Sundry ID: 2672251

Type of Action: Plug and Abandonment

Plug and Abandonment Procedure
for
DJR Operating, LLC
Cinco Diablos 14
API # 30-039-20202
NE/SW, Unit K, Sec. 14, T23N, R4W
Rio Arriba County, NM

CONDITIONS OF APPROVAL

Proposed Wellbore Diagram
DJR Operating, LLC
Cinco Diablos 14
 API # 30-039-20202
 NE/SW, Unit K, Sec 14, T23N, R4W
 Rio Arriba County, NM

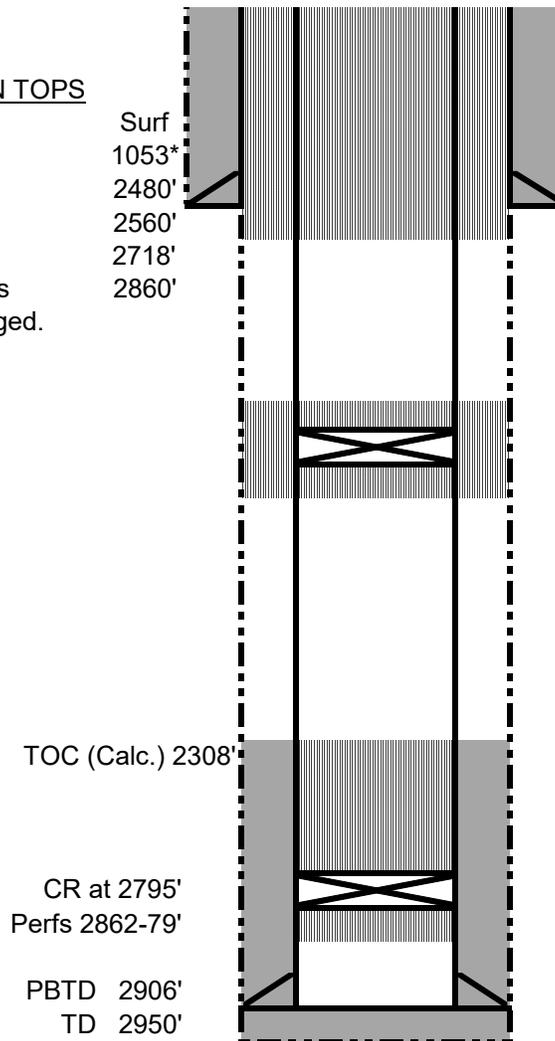
You are also required to place cement excesses per 4.2 and 4.4 of the attached General Requirements.

- 4.6 **A cement bond log or other accepted cement evaluation tool is required to be run if one had not been previously ran or cement did not circulate to surface during the original casing cementing job or subsequent cementing jobs.**

Created By	Condition	Condition Date
kpickford	CBL required	5/31/2022
kpickford	Notify NMOCD 24 Hours Prior to beginning operations	5/31/2022
kpickford	Adhere to BLM approved COAs and plugs. See GEO report.	5/31/2022

Plug 4: Surface shoe and surface plug: Perf holes at 152'. Tie onto 4-1/2" casing and mix and pump sufficient cement to bring TOC to surface, inside and outside.

Plug 3: Nacimiento top: Perf holes at 1103'. Set CR near 1053'. Mix and pump sufficient volume to bring TOC to 1003', inside and outside.

Plug 2: Pictured Cliffs, Fruitland, Kirtland, and Ojo Alamo tops. Run CBL. Spot cement from top of CR to 2430'. Cement plug may be changed based on CBL run.

Plug 1: Pictured Cliffs Perfs: Set CR near 2840'. Attempt to squeeze 10 sx below CR.
